Technical Service Bulletin

| SUBJECT: HVAC MODE DOOR POP/CLICK NOISE | | No: TSB-12-55-006 | |
| | | MODEL: 2013 Outlander Sport/ RVR | |

FOR REFERENCE

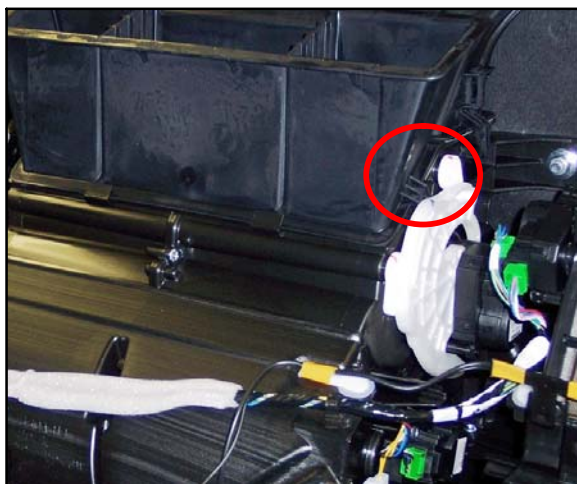
Correct clip position shown with HVAC assembly removed from the vehicle and mode door pivot cam removed.

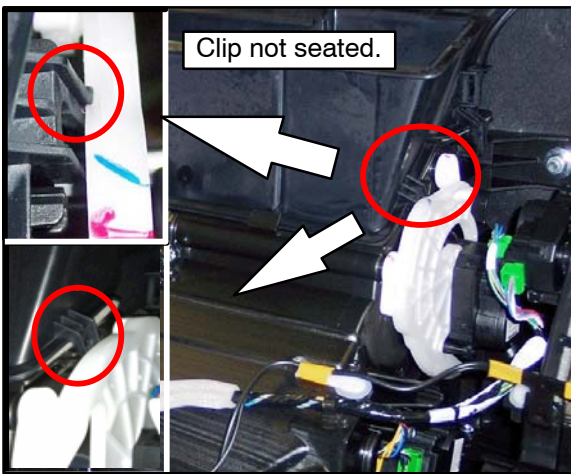
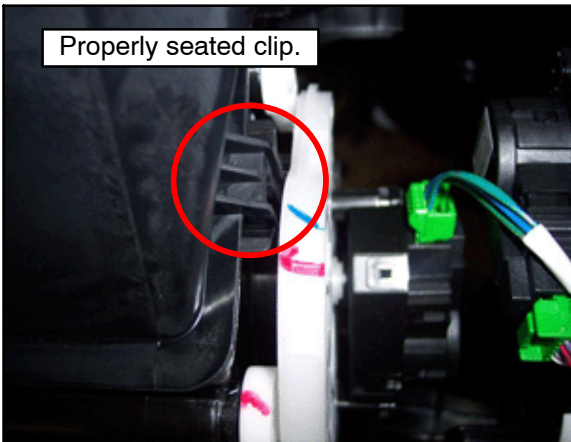
2. Turn the ignition ON (*Vehicles with OSS* – green light in “Start/Stop” button, engine not running).
3. While watching the mode door pivot cam, rotate the mode selection dial to various positions, stopping for several seconds at each position.
4. The cam will deflect slightly when you hear the pop/click noise.

1. If a noise is confirmed, place the mode selection dial to the “face” position.
2. Locate the vent duct clip next to the mode door pivot cam. Examine the position of the vent duct clip.
 - a. If the clip is properly seated, further diagnosis is required. Follow procedures in the service manual to diagnose and repair the condition.
 - b. If the clip is not properly seated, press on the clip using a flat blade screwdriver to seat it. You may also have to press downward.
3. Confirm the noise is no longer present when changing the HVAC mode.
4. Reassembly is the reverse of disassembly. Refer to Group 52A – Interior, in the 2013 Outlander Sport Service Manual for details.
